Georgetown Charter Township

Planning Commission Meeting Agenda

SITE PLAN
WW GREENHOUSES
4044 CHICAGO DR.

GRADING + SOIL EROSION CONTROL PLAN
6555 CENTER INDUSTRIAL DRIVE

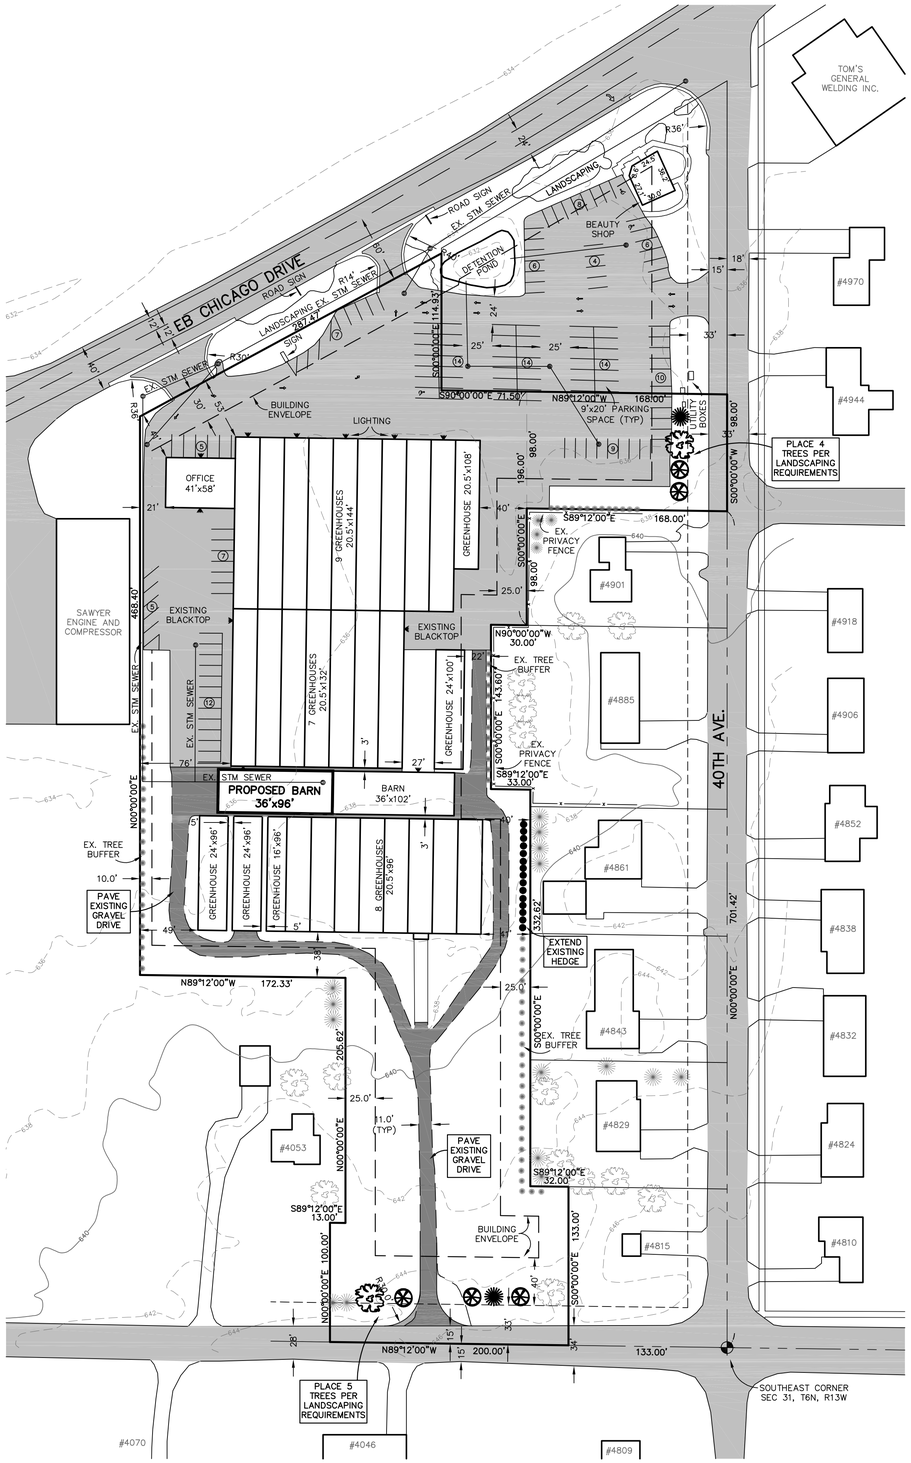
1) The front yard setback is required to be 30 feet from the property line. Chapter 24 footnote l states that the required front yard setback (30 feet) shall be landscaped and not used for parking or drives. L**andscaping and landscaping calculations along Chicago Dr. and 40th Ave. were provided.**
2) The side yard setbacks are 10 and 15; however, the Planning Commission will determine if the requirements are met in Sec. 26.3(D) for a greenbelt for a parking area adjacent to a residential district. The adjacent property to the east and south is all LDR and the 25 foot greenbelt is required. **Landscaping calculations were provided.**
3) The rear yard meets the requirement to be 40 feet. **Landscaping or the greenbelt along New Holland was provided.**
4) **The building at the corner of Chicago Dr. and 40th Ave. is not included in this proposal.**

As per the plan, landscaping and greenbelt calculations were provided for along Chicago Dr., 40th Ave. and New Holland. Some additional landscaping is proposed; however, the plan shows that much landscaping already exists. The applicant is asking for the Planning Commission to determine that the existing landscaping meets the ordinance requirements for streetscape and for greenbelts.

The Planning Commission should determine if the landscaping and greenbelts as proposed (with the addition of landscaping as noted on the plan and with the existing landscaping and greenbelt) meets the ordinance requirements for streetscape and greenbelts.

b. Lot coverage was provided and meets ordinance requirements since a variance was granted in 1988.

c. The driveway is noted to be paved.

e. Sign and lighting details were provided. They currently exist and no changes are proposed.

f. As per the parking calculations, 74 spaces are required and 61 spaces are provided on the site and an additional 60 are shared from the neighboring site.

h. **A Storm Water Drain permit (written approval) from the Ottawa County Water Resources Commissioner's office will be required at the time a Zoning Compliance/building permit application is submitted**.

drained so as to dispose of all surface water. **Variance granted for northern section only. A hard surface for the southern driveway is noted on the plan to be provided.**

(8) All lighting shall be shielded from adjacent residential areas. **Lighting is noted on the plan and appears to meet this standard.**

SITE LAYOUT + UTILITY PLAN
6555 CENTER INDUSTRIAL DRIVE

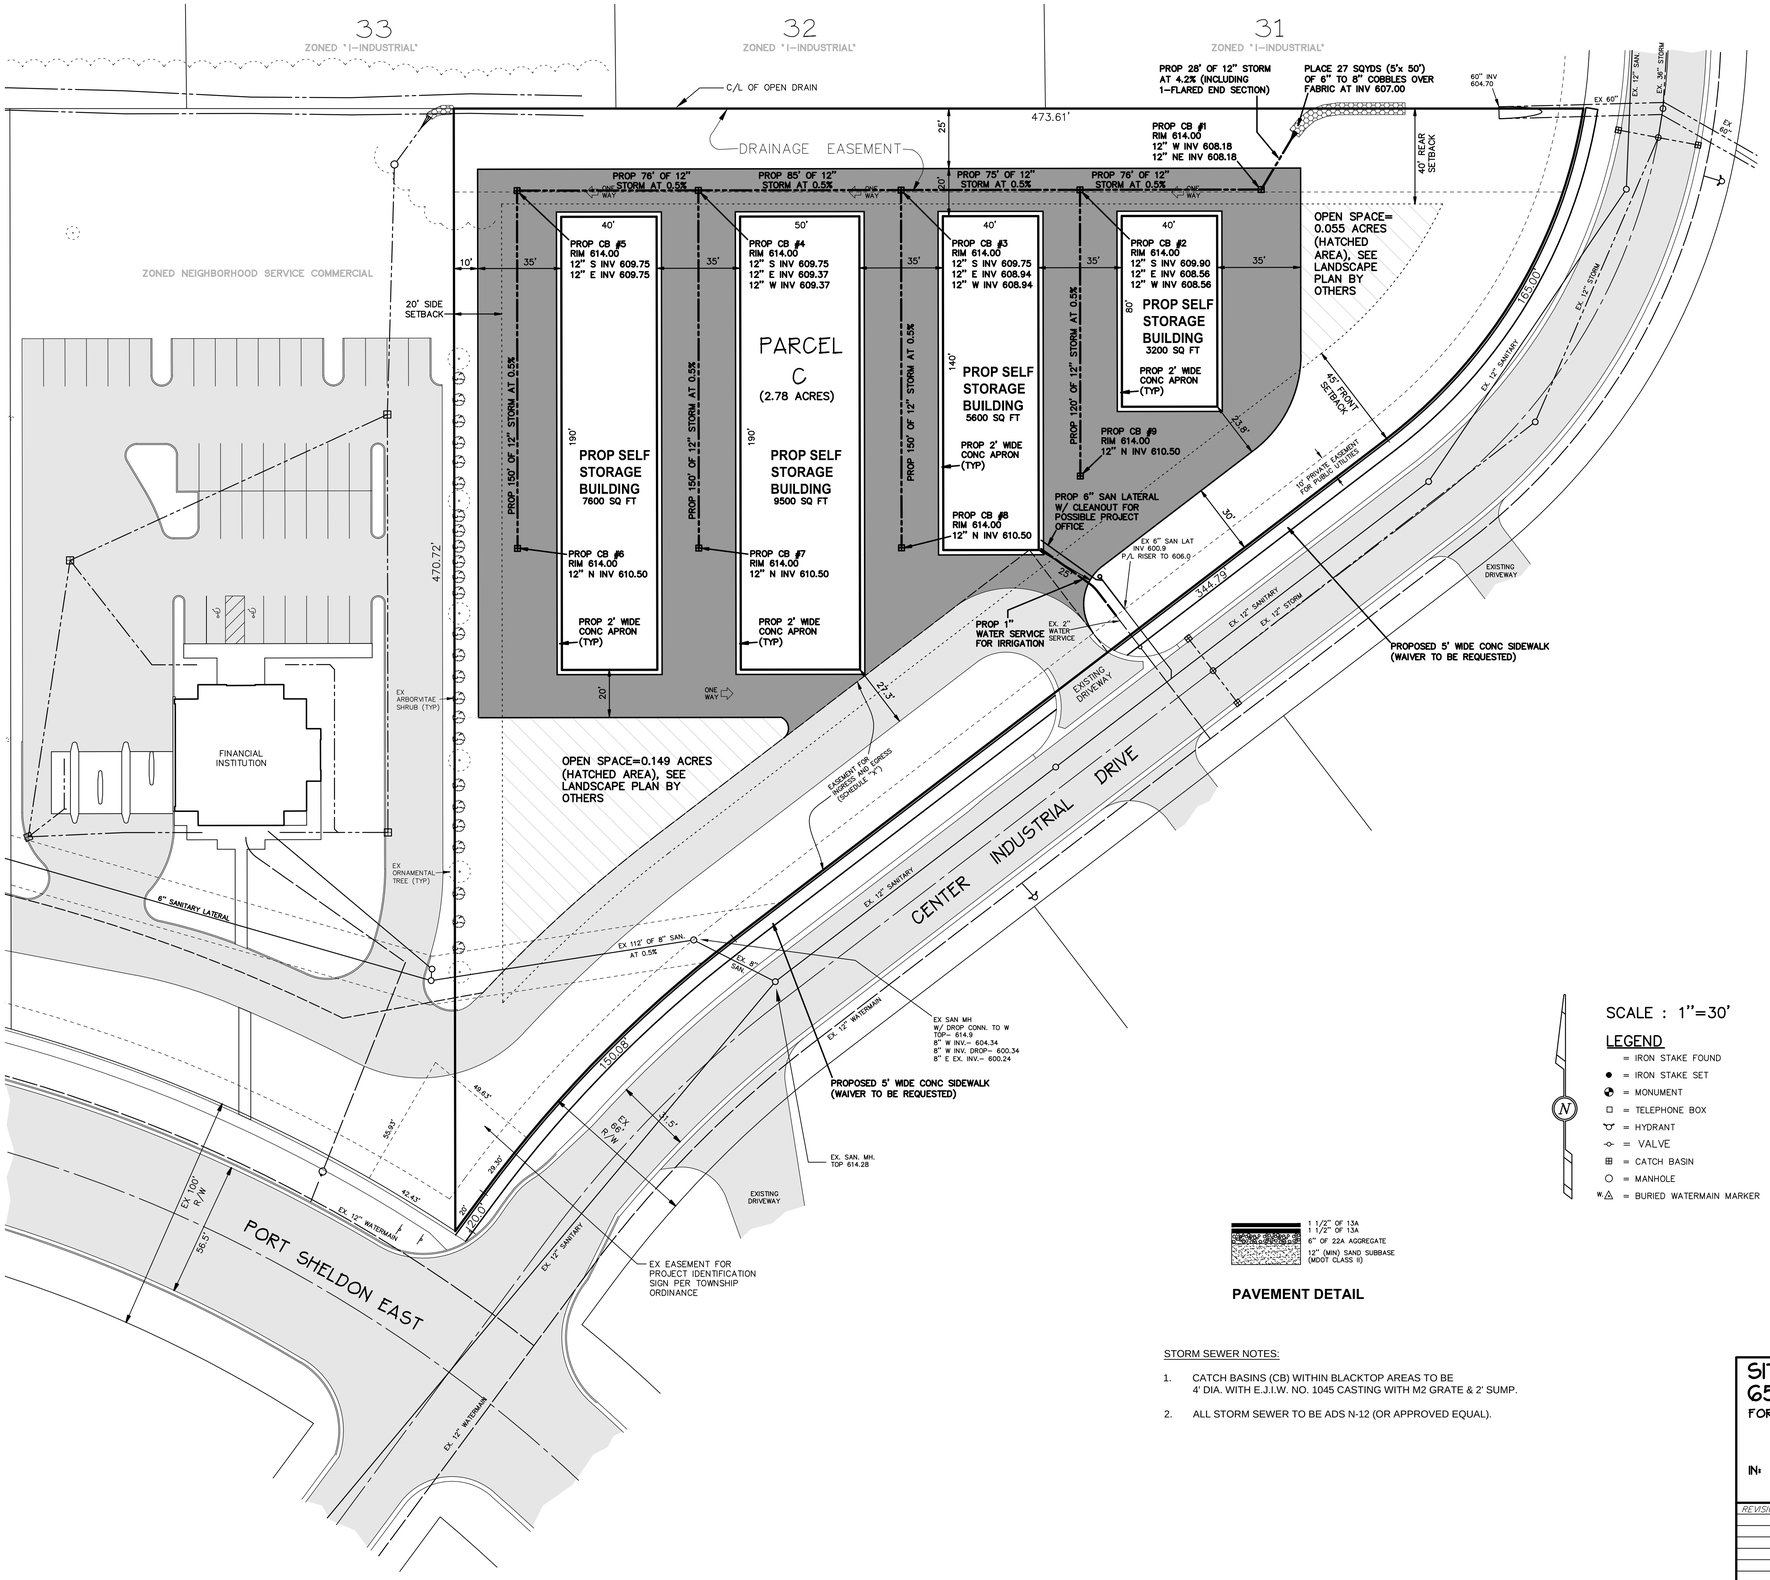
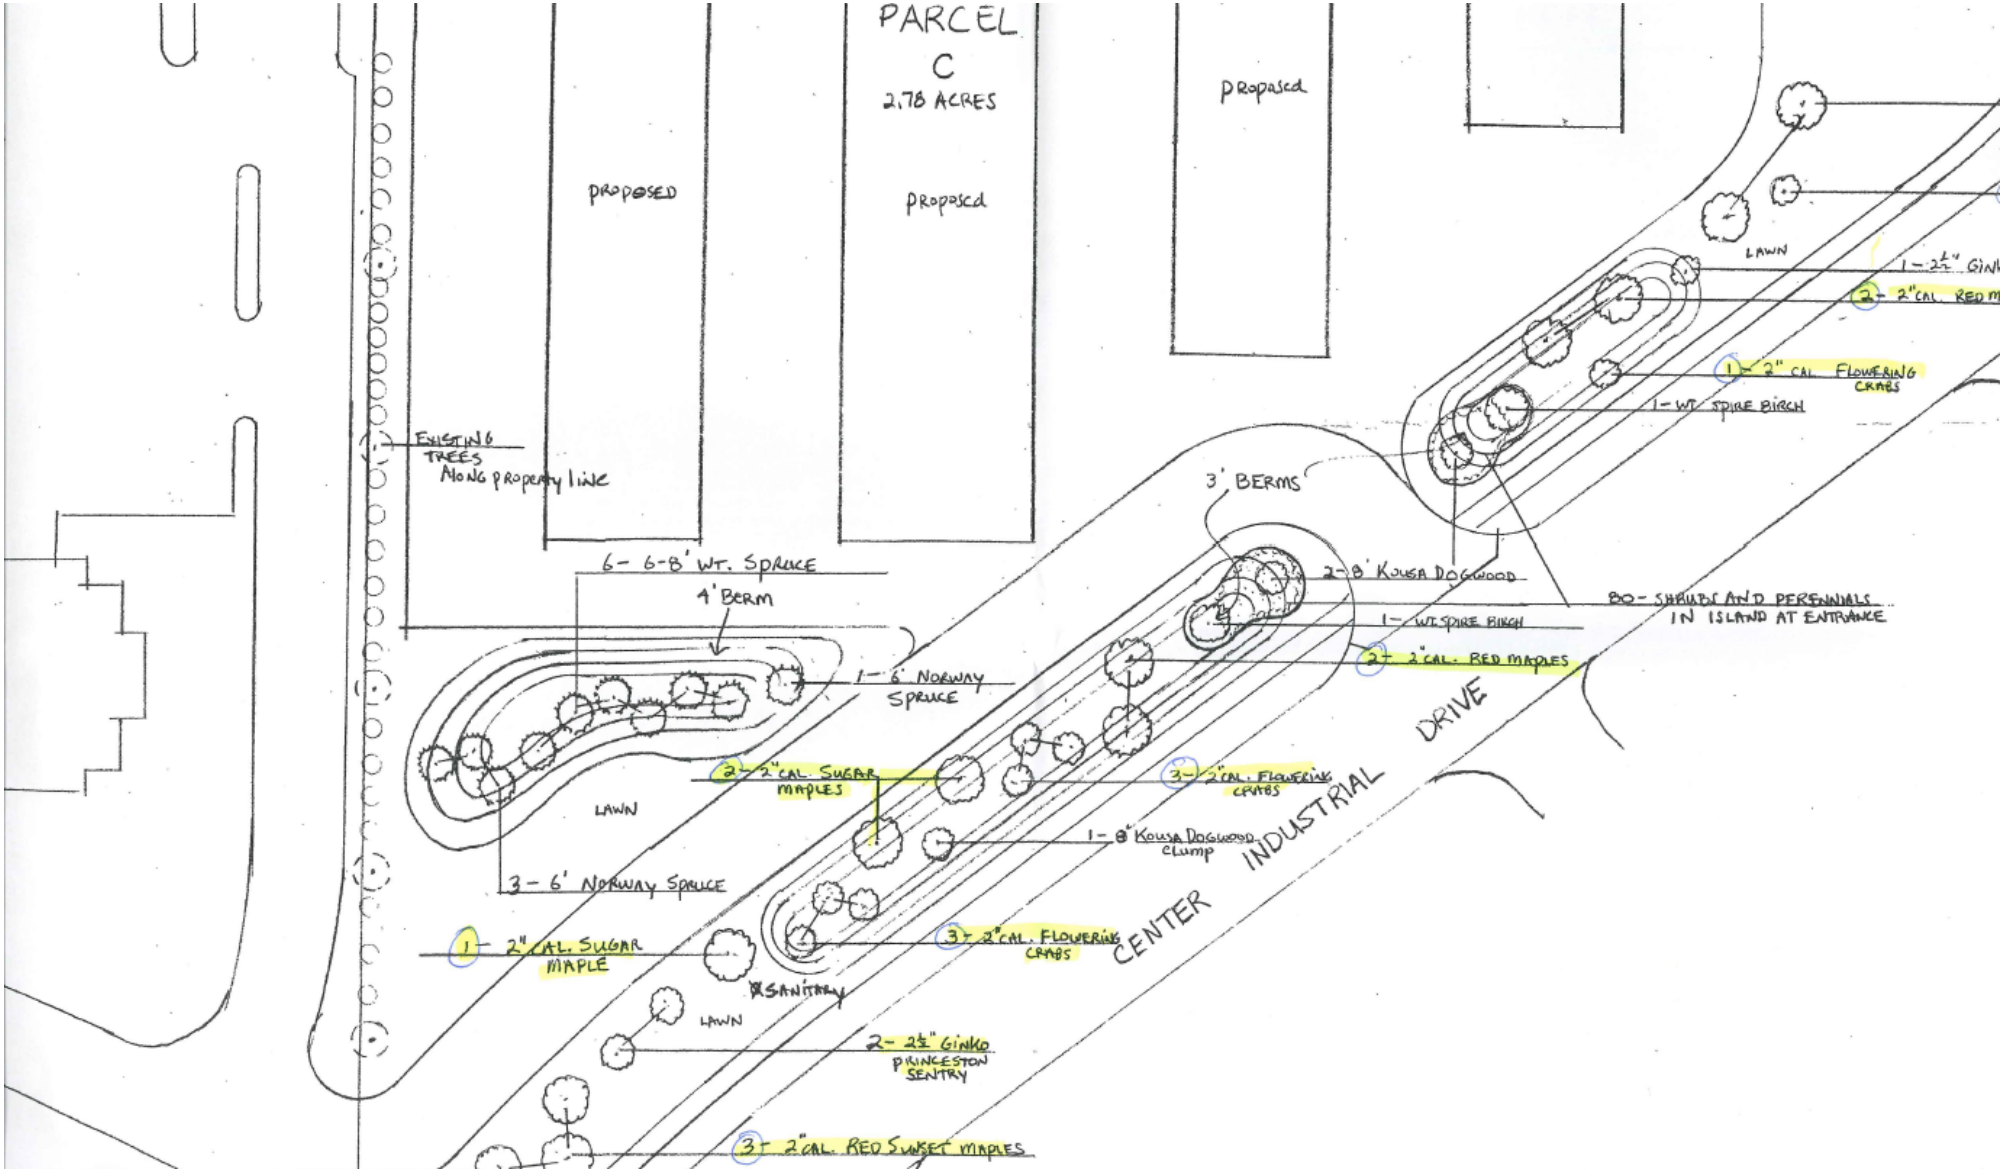
5. **Open Space.** A total of 0.21 acres of open space is proposed, which is 7.5%, less than the 20% that is required**.** Ten evergreens are proposed to be planted on a berm in the open space. **The determination is that the proposal _____ (does or does not) meet the ordinance requirements for open space.**

The parcel is 2.78 acres and 20% is 0.56 acres. The plan shows 0.06 acres of open space at the northeast corner and 0.15 acres at the south corner for a total of 0.21 acres which is 7.5%, less than what is required. Even if the open space is not set apart for "active" usability, it could be set apart for "passive" usability such as for detailed and extensive landscaping. Nothing has been provided indicating what will be in these areas. Landscaping is provided in the open space (10 evergreens). The Planning Commission and Township Board will determine if this proposal meets the ordinance.

PROVIDED; however, the Planning Commission and Township Board will have to determine if the amount is acceptable. Landscaping (10 evergreens) is shown within the open space.

None are provided within the site and a waiver is requested from the Board to eliminate the requirement of sidewalks along Center Industrial Dr. The Planning Commission and Township Board will have to determine if the amount is acceptable.

Styles NOT PROVIDED but a note on the plan indicates that lighting poles will be a maximum of 25 feet tall and will be downward directing.

The following is the Future Land Use Map related to the proposed PUD development.

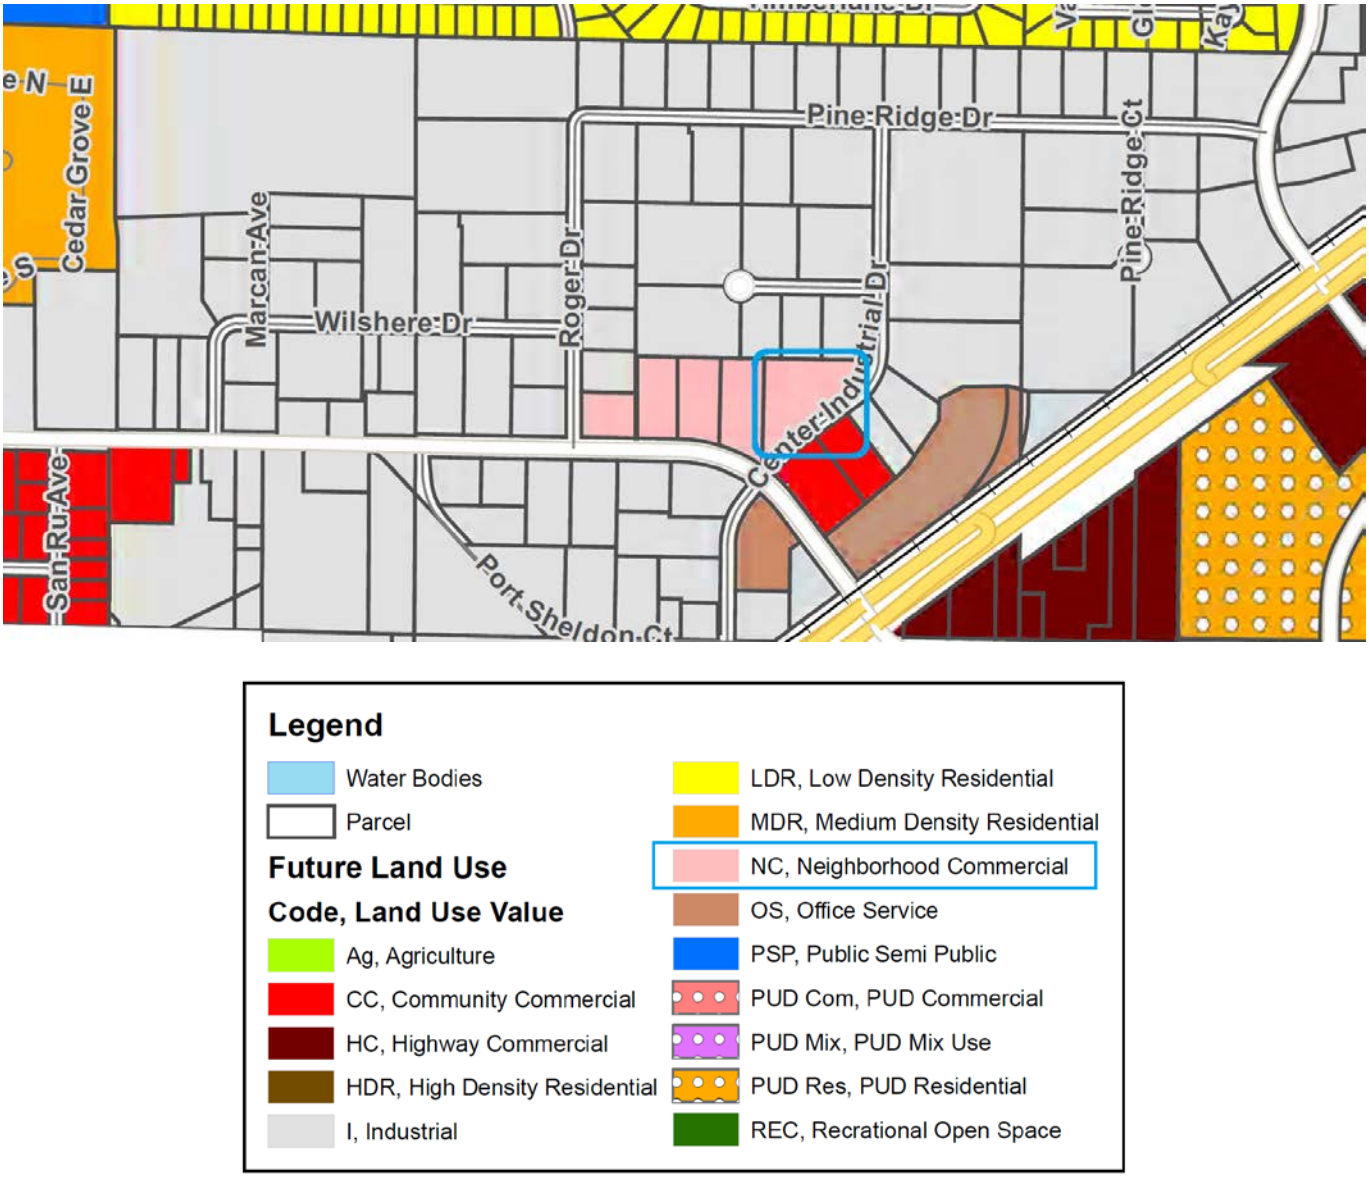
The Planning Commission will determine if this standard is met. The Future Land Use Map designates the parcel to be NC (Neighborhood Commercial). However, the site is adjacent to the Industrial designation and page 35 of the Master Plan states that the lines separating use categories are NOT to be considered as defined line and are not necessarily parcel specific.
